NTSB No. CEN15MA290

Airbus Helicopters Service Bulletin No. AS350-67.00.64 (63 Pages)

SUBJECT: ROTOR FLIGHT CONTROLS - Double hydraulic servocontrols

"HYDR" test indication for double hydraulic servocontrols
 Corresponds to modification 074622

Figure 15

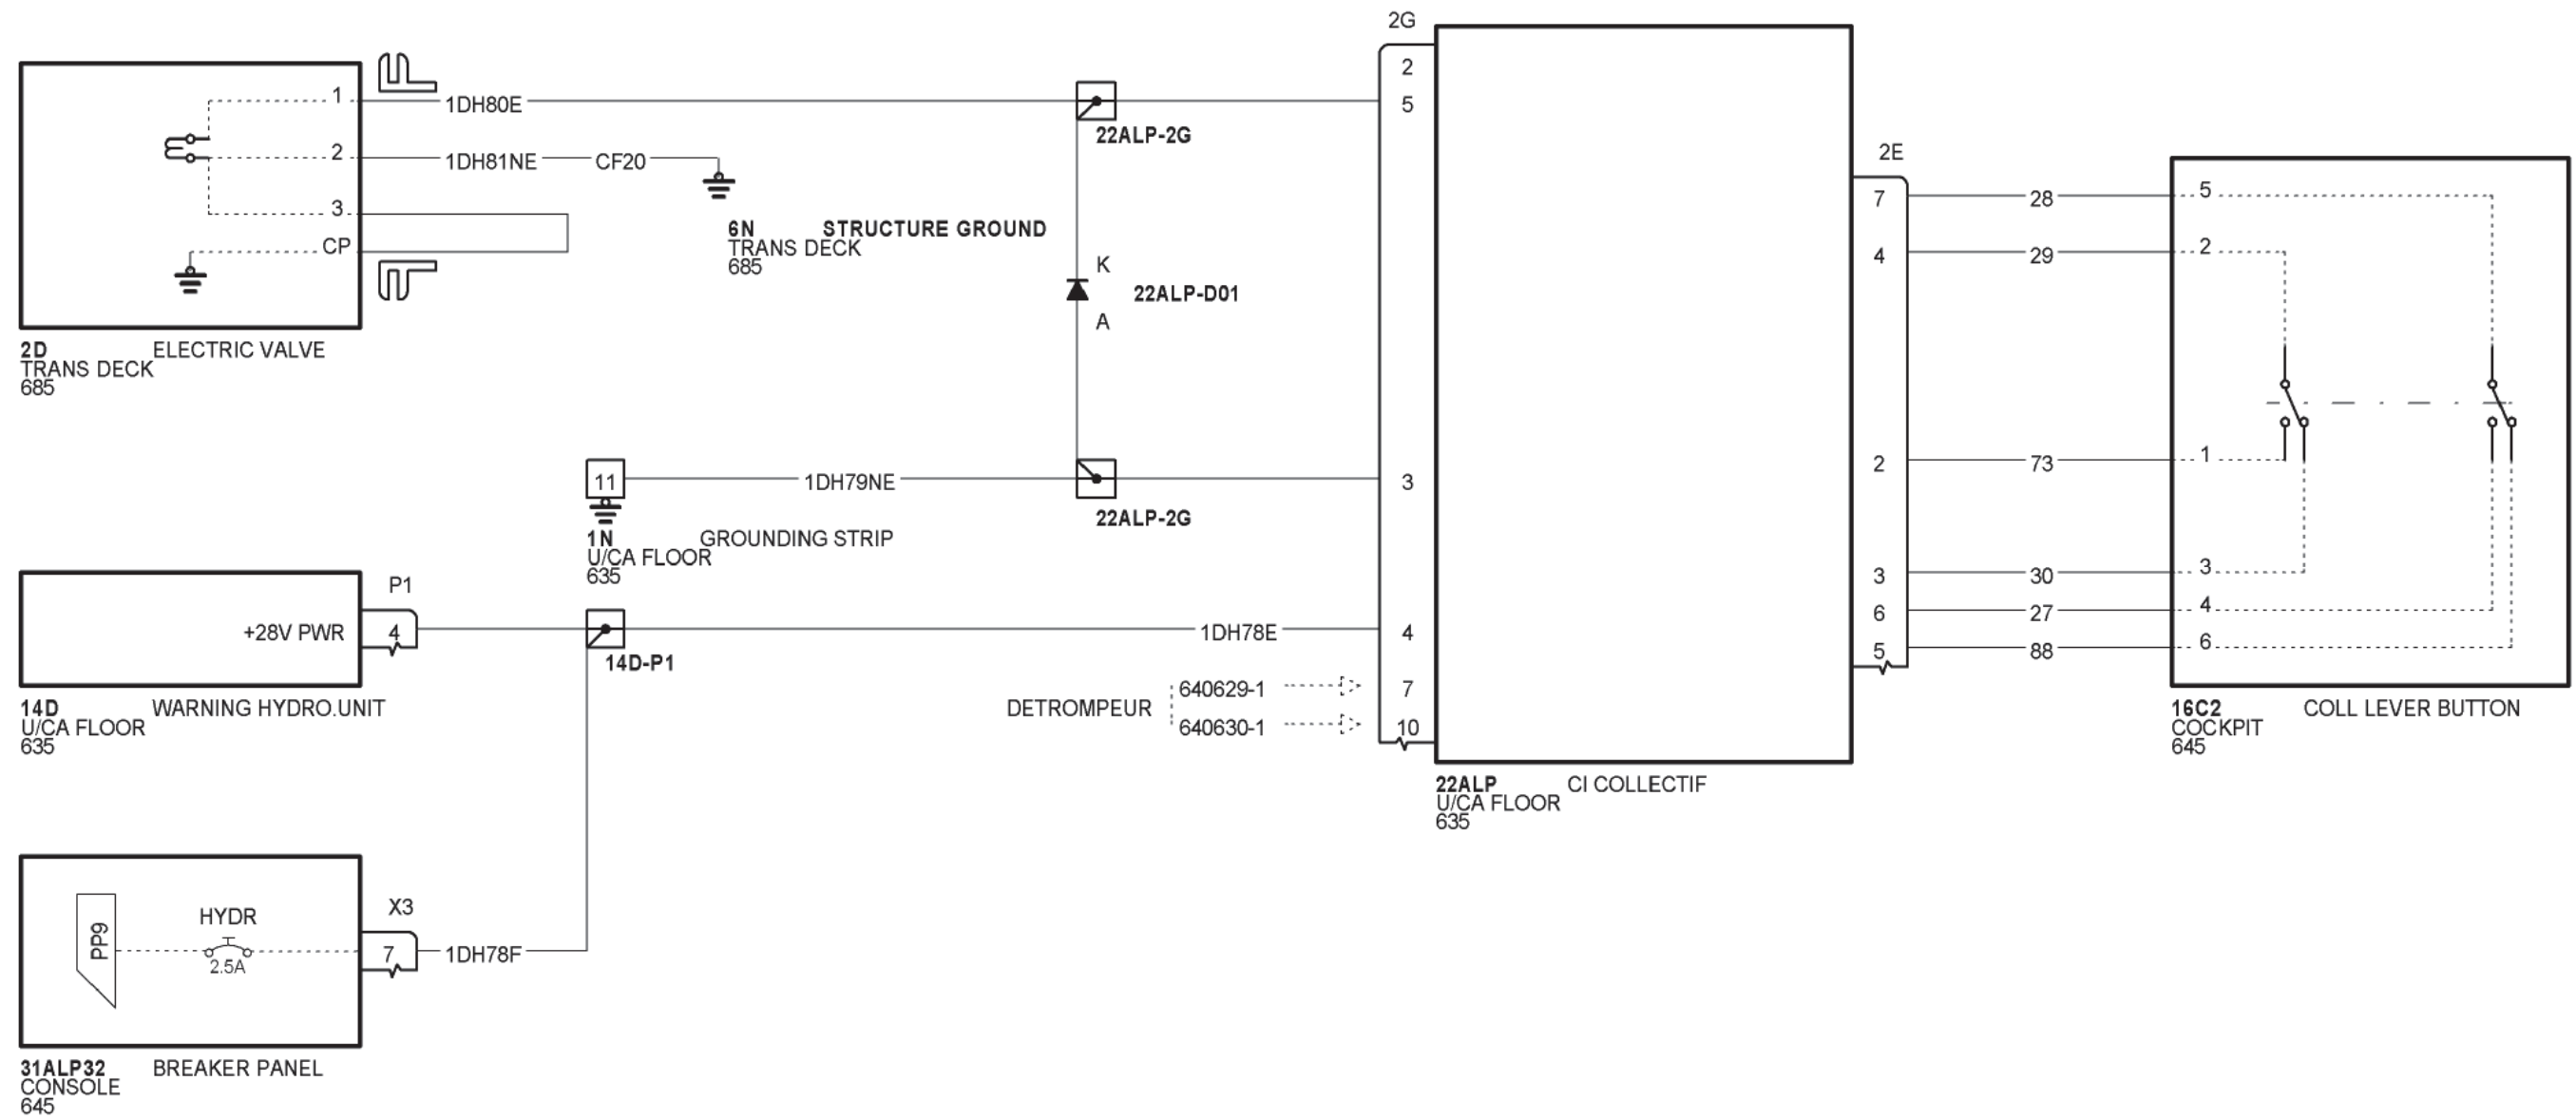
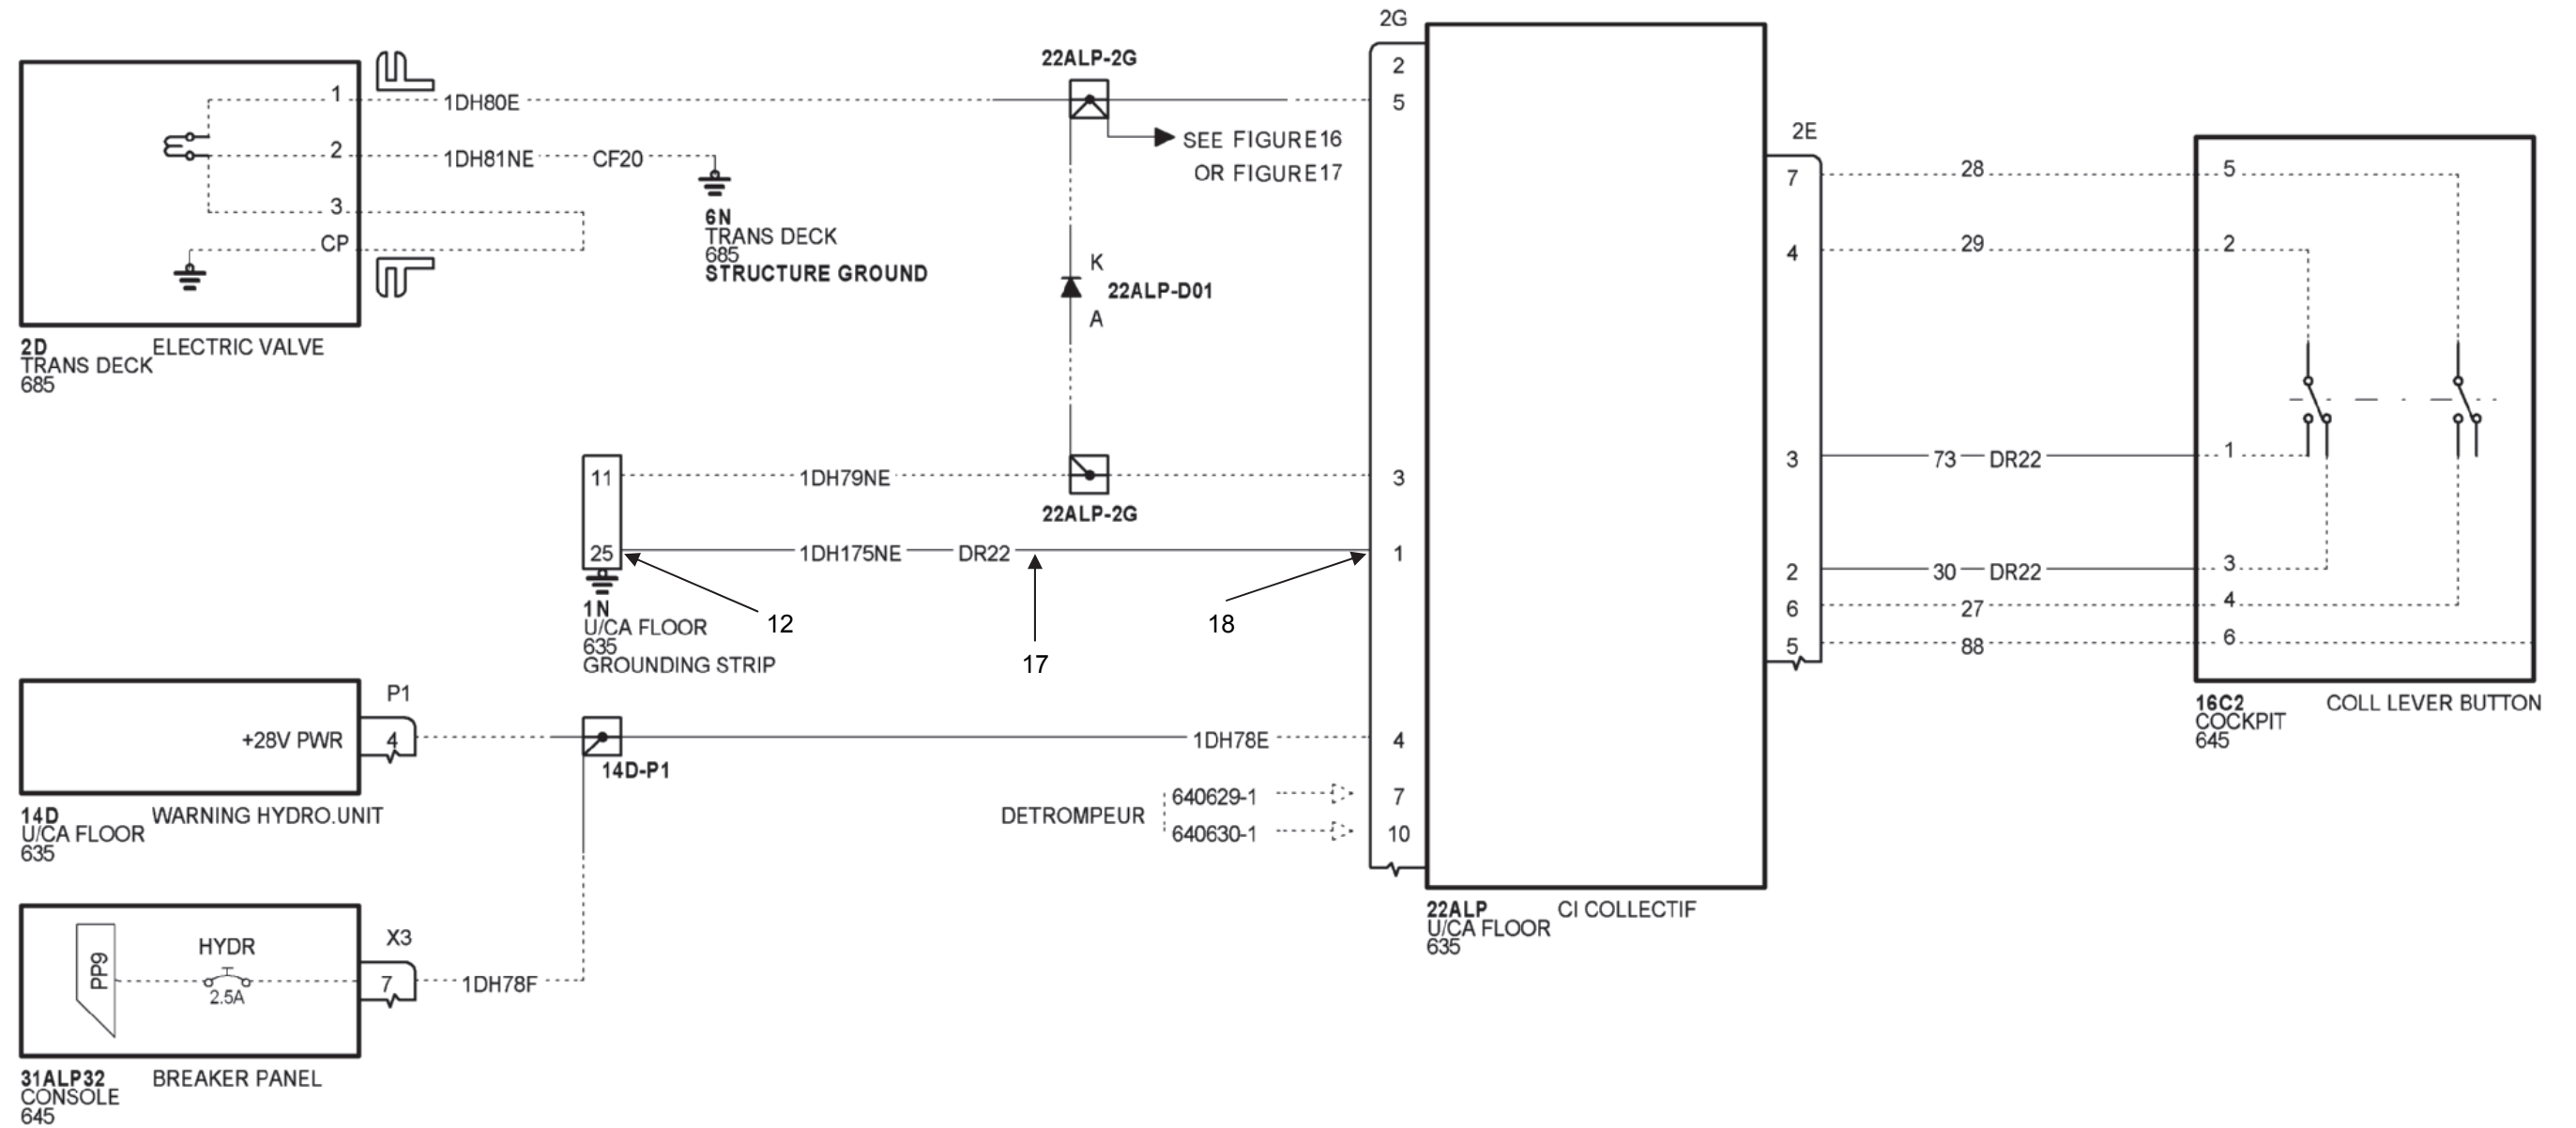
3.B.2.b.5. For helicopters POST OP 3346 and PRE MOD 073368 (Figures 1, 14, 15 and 16)

- Cut and discard the binding clamps (not shown on Figures) that hold the electrical harnesses.
- Install base (3) on relay support (14) (Figure 1) with its bolts and nuts.
- Route the wiring using sets of wires and markers (17) and wire to contacts (4), (8), (10) and (11), ground contacts (12) (refer to appendix 4.A.), PCB (CI) contacts (18) (refer to appendix 4.B.) and extensions (9) and (19) as per Figures 14, 15 and 16.
- Carry out a continuity test of the modified wiring.
- Install timer relay (2) on base (3).
- Attach the electrical harnesses with binding clamps (31) or (32) (not shown on Figures).

Figure 17

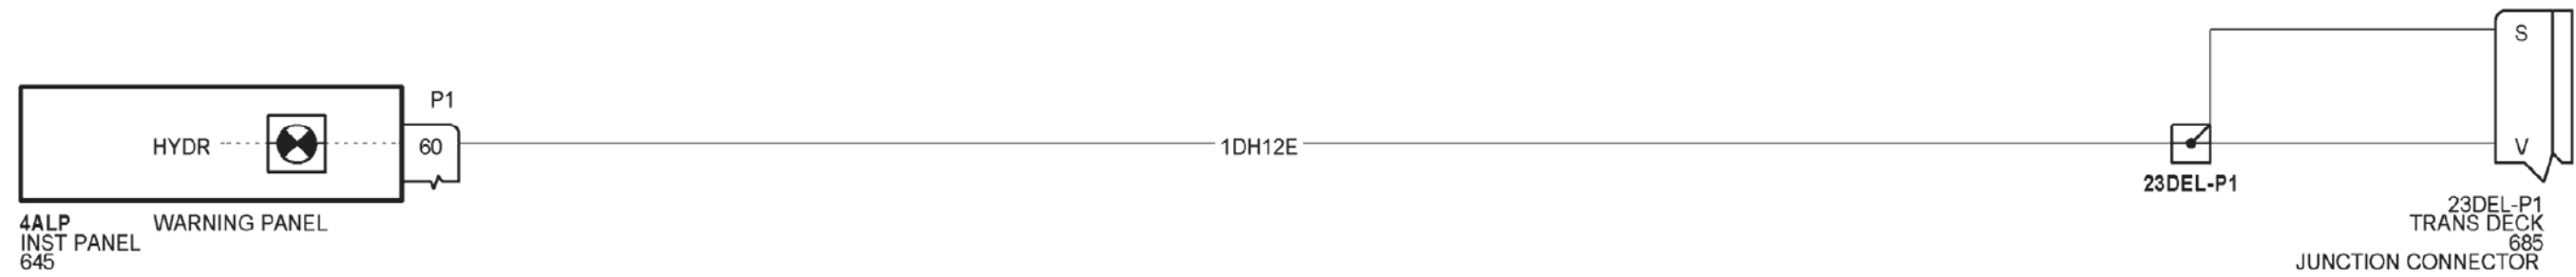
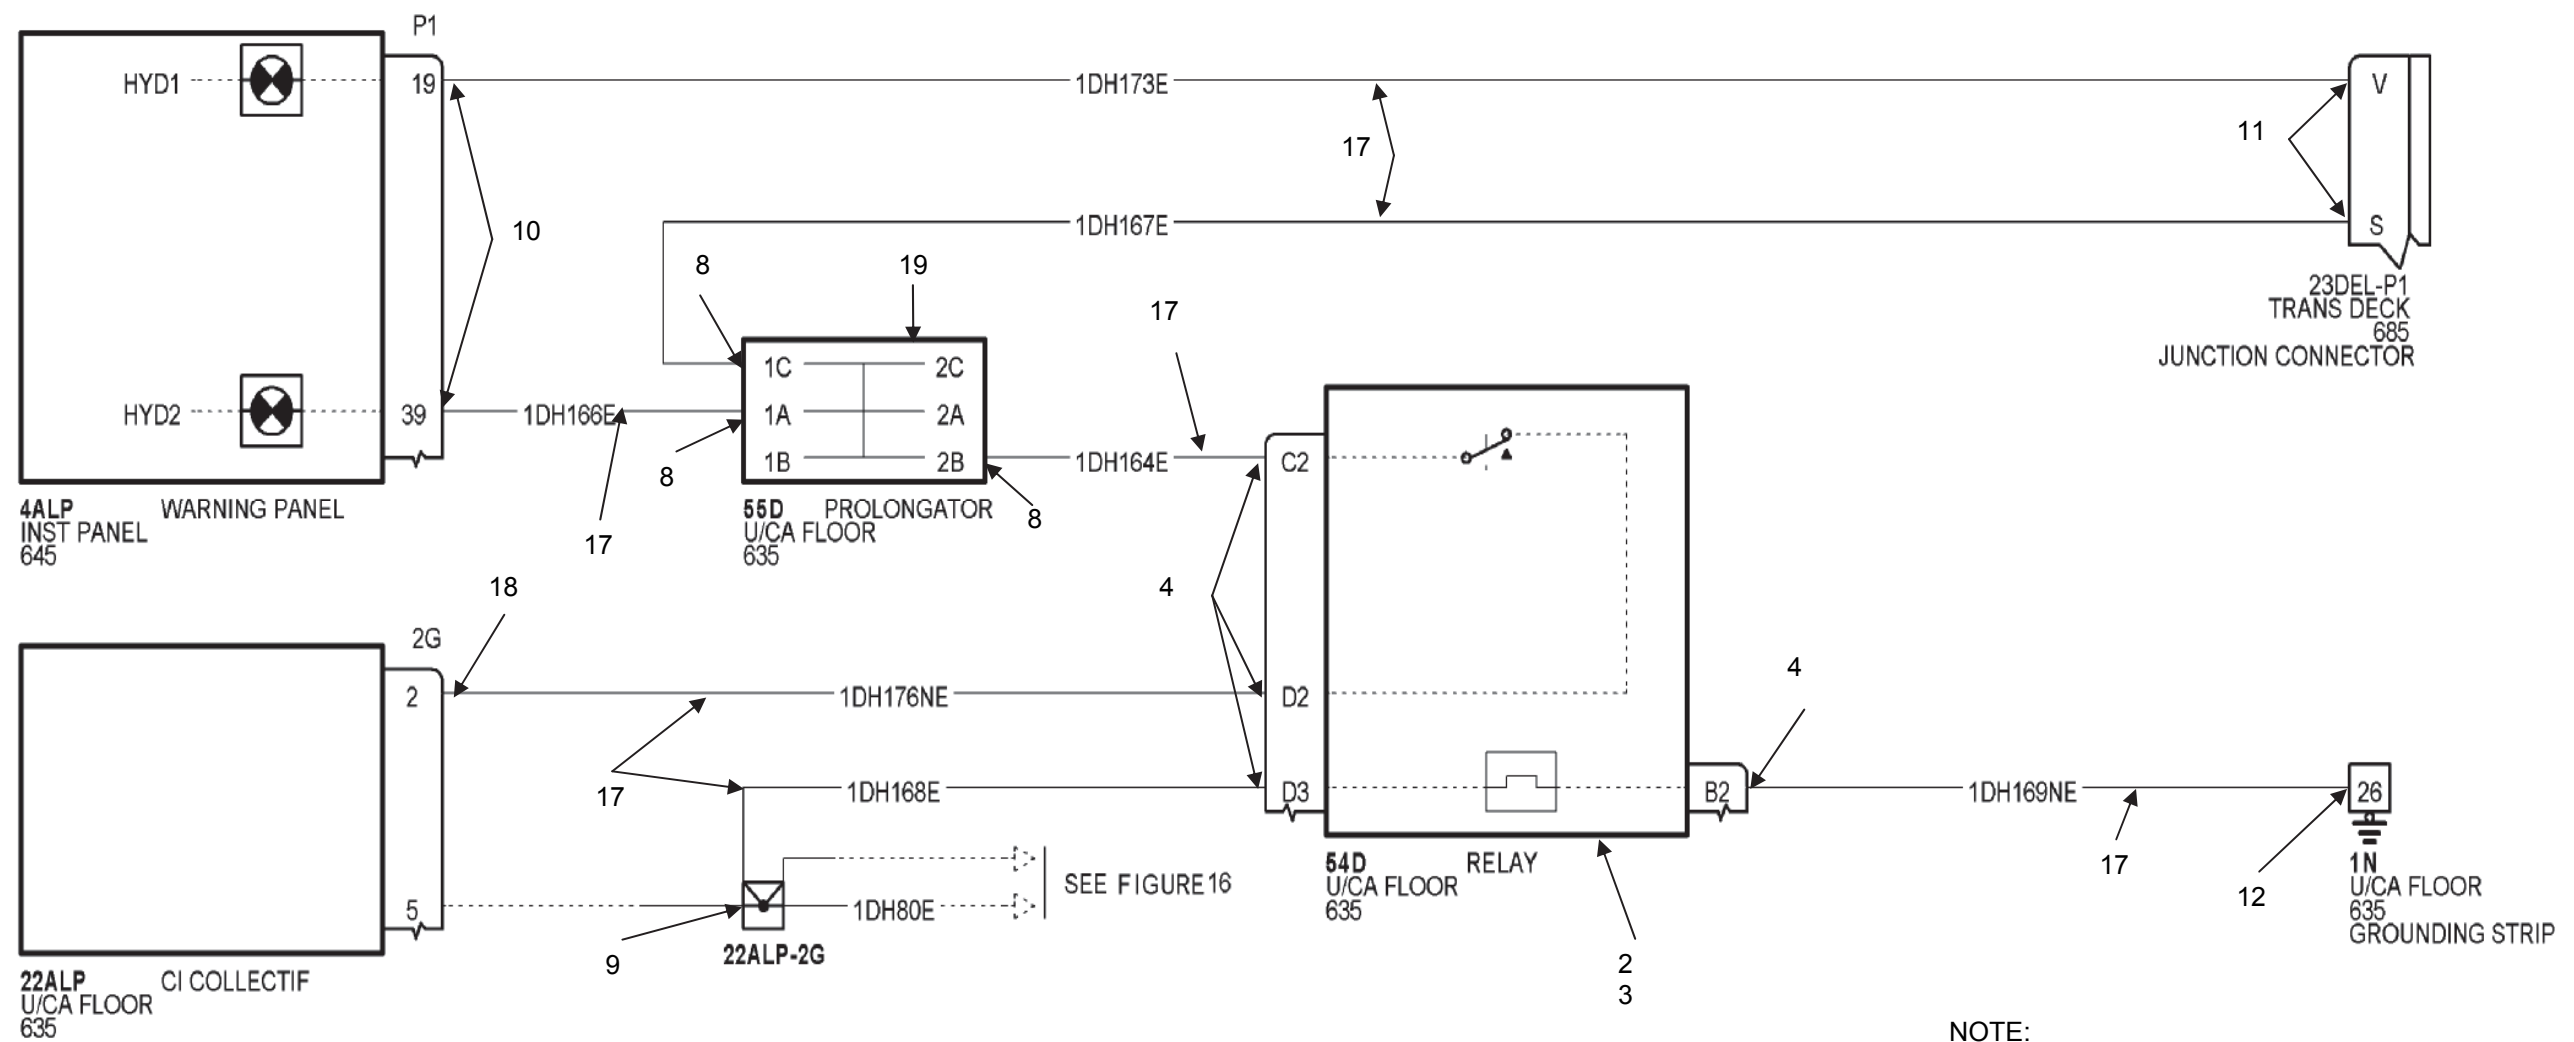
3.B.2.b.6. For helicopters POST MOD 073368 and POST MOD 073391 and PRE MOD 073450
(Figures 1, 15, 16, 17, 18 and 19)

- Cut and discard the binding clamps (not shown on Figures) that hold the electrical harnesses.
- Install base (3) on relay support (14) (Figure 1) with its nuts and bolts.
- Route the wiring using sets of wires and markers (17) and wire to contacts (4), (8), (10) and (11), ground contacts (12) (refer to appendix 4.A.), PCB (CI) contacts (18) (refer to appendix 4.B.) and extensions (9) and (19) as per Figures 15, 16, 17, 18 and 19.
- Carry out a continuity test of the modified wiring.
- Install timer relay (2) on base (3).
- Attach the electrical harnesses with binding clamps (31) or (32) (not shown on Figures).
